UNITED STATES PATENT AND TRADEMARK OFFICE

Office Action Summary	Application No. 10/827,407	Applicant(s) TANG, SHU-LIEN	
	Examiner Julian Mercado	Art Unit 1745

DETAILED ACTION

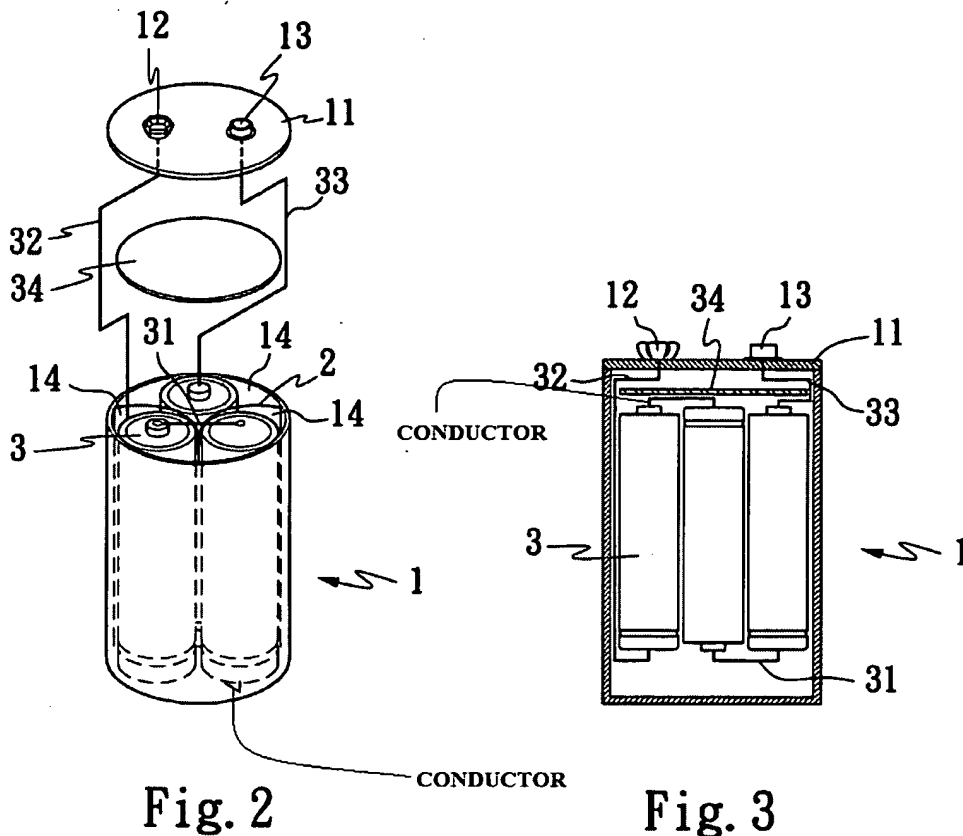
The drawings are objected to because the conductors [31], [32] and [33] appear to remain as a open circuit even when connected to a load. See Figure 3 in comparison to Figure 2 with attention to conductor [32]. In Figure 3, note that conductor [31] is shown to connect the second and third batteries, while in Figure 2 the same conductor is shown to connect the first and second batteries. It appears to the examiner that Figure 3 should show all connection points since the Figure is a cross-section. Optionally, Figure 2 should also show the connection points, while it is understood as less important since this Figure is a perspective view and the connection may be hidden in the drawings. The examiner has attached herein suggested modifications for the drawings, labeled with "CONDUCTOR".

Corrected drawing sheets in compliance with 37 CFR 1.121(d) are required in reply to the Office action to avoid abandonment of the application. Any amended replacement drawing sheet should include all of the figures appearing on the immediate prior version of the sheet, even if only one figure is being amended. The figure or figure number of an amended drawing should not be labeled as "amended." If a drawing figure is to be canceled, the appropriate figure must be removed from the replacement sheet, and where necessary, the remaining figures must be renumbered and appropriate changes made to the brief description of the several views of the drawings for consistency. Additional replacement sheets may be necessary to show the renumbering of the remaining figures. Each drawing sheet submitted after the filing date of an application must be labeled in the top margin as either "Replacement Sheet" or "New Sheet"
